## MEMORANDUM

TO: SQZ team  
FROM: Daniel Sigg, Marc Pirello  
SUBJECT: Modifications to the Optical Fiber Switch  
Refer to: LIGO-E1700364-v2

This document lists the modifications to the Optical Fiber Switch based on v1 schematic located here [D1700326](#).

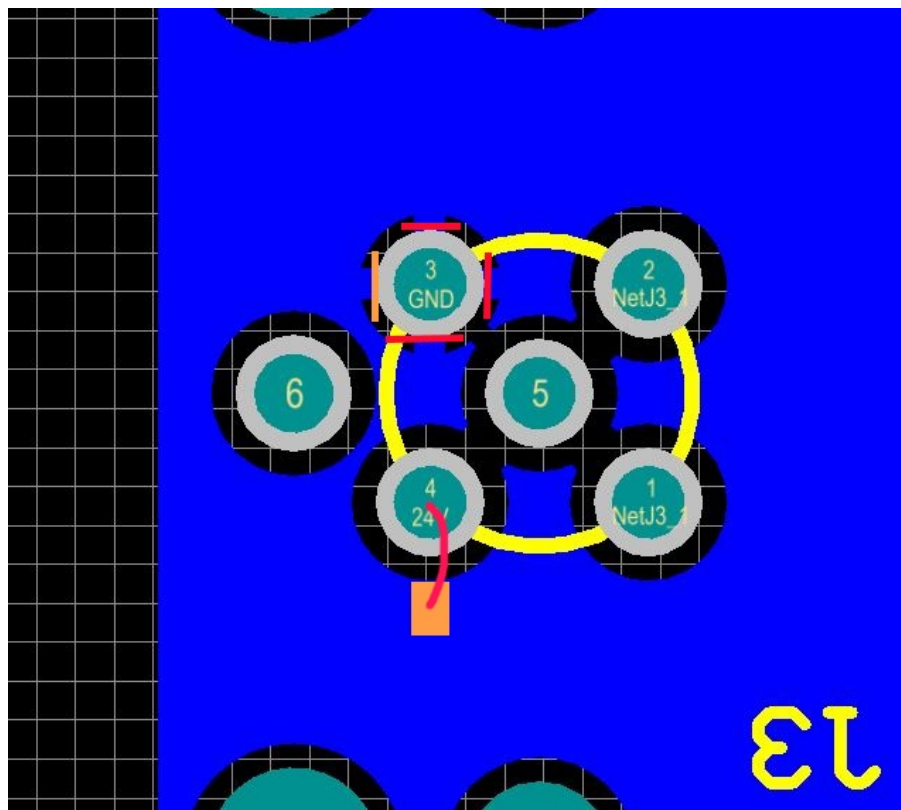
#### Change 1:

Cut all four thermals on underside of PCB around pin 3, ensure they are not electrically connected to the GND plane. Also, remove solder mask next to pin 4 and bridge from pin 4 to the cleared solder mask (pad).
